PRODUCTS: Dunkirk Boilers - Hotline Series Indirect Water Heater

Subject: Coil Change

Models Effected: HL-30, 40, 50, 80 & 119

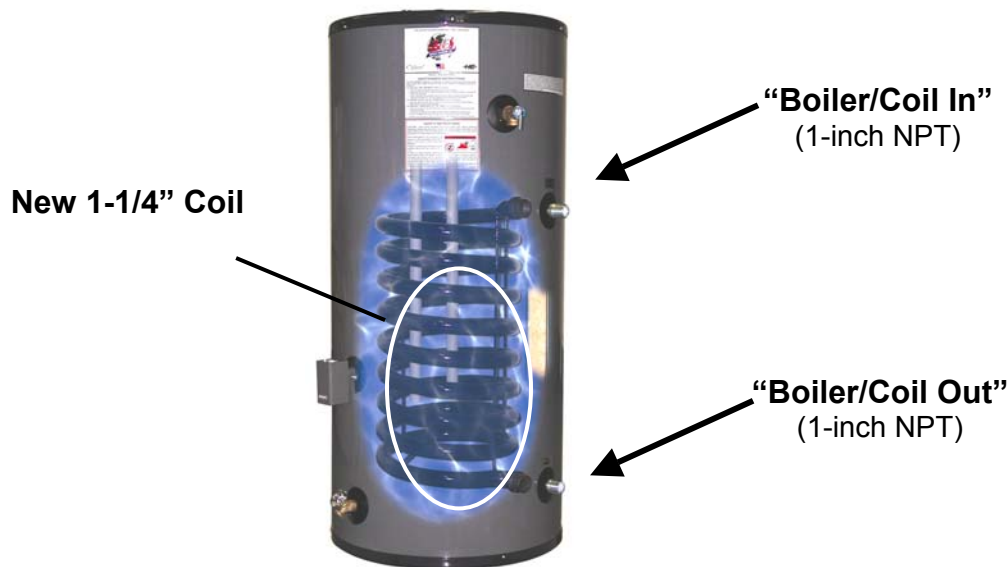
Effective immediately the HotLine Series Indirect Hot Water Heaters have changed as follows: (see illustration below)

- HL30, HL40 & HL50 have relocated their "boiler/coil in" and "boiler/coil out" tapings. Previously on the top, these connections are now on the side of the tank.
- All HotLine sizes (HL30 - HL119): Internal coil diameters have increased from 3/4" to 1-1/4". Coil connections for all sizes will now be 1-inch NPT.

NOTE: The change in the coil does not effect the location or size of the domestic Hot and Cold connections.

- Better heat transfer due to more coil surface area resulting in improved output (recovery rate) of the tank.
- Improved flow through coil due to lower head loss.
